6300204 CONDUIT  
COMMENTS FROM INTERNAL/INDUSTRY REVIEW

Comments: (8/9/22, Industry)

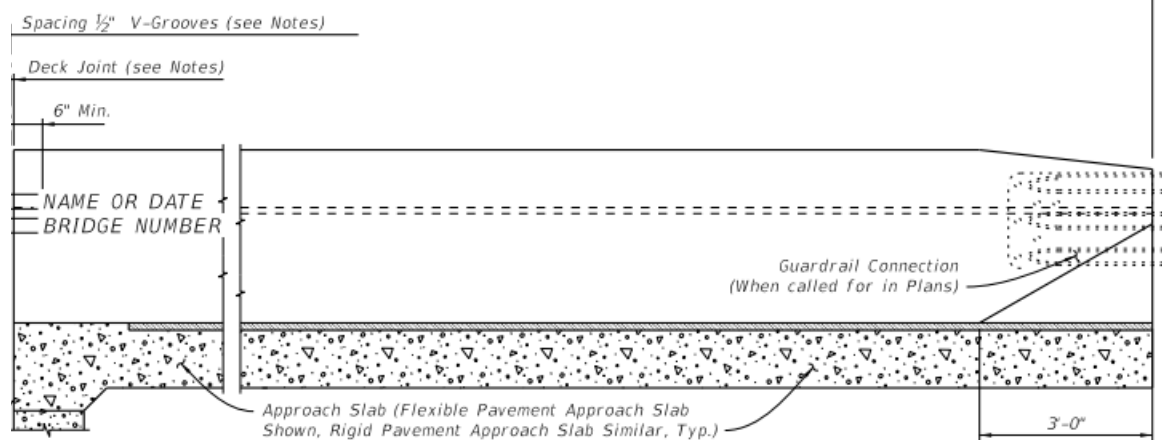
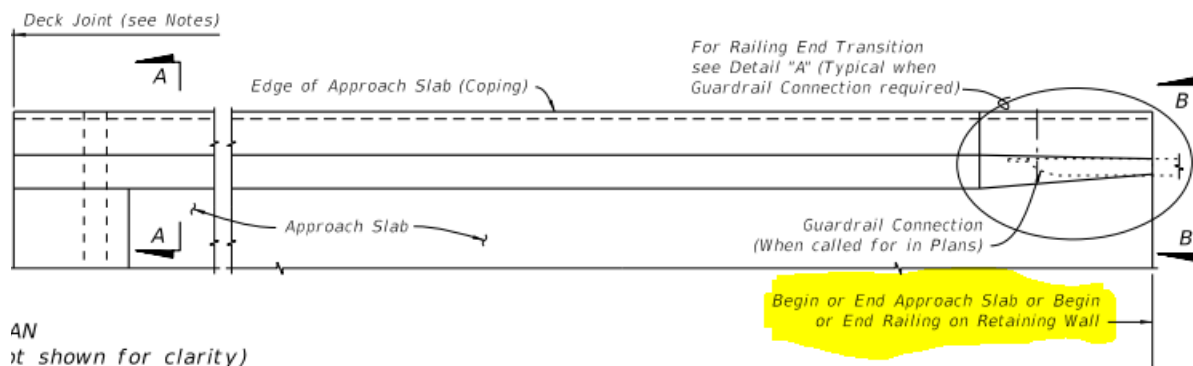
>> " Our discussion was always about the fact that the payment measurements ended at the pull box which is generally 6' from the end of the bridge but the conduits went the full length of the approach slab (+/-) before terminating."

>> "Some think that the pay quantity will be the length of the barrier instead of each run."

Understood. Perhaps the confusion comes from not yet seeing the new Standard Plans, Index 630-010. We will be adding a clarifying statement seen below.

The end of rail and the end of approach slab for new construction will be the same. All current Standard Plans for bridge rail already shows Begin or End of Approach Slab coinciding with Begin or End of Railing.

The measured length will be the same. The language states "for each conduit" clarifying that if there are two individual conduit runs within the railing you'll get paid for both, and the length for each will be the length of the railing. If there are three individual conduit runs, you'll get paid for all three and the length of each will be the length of the railing.
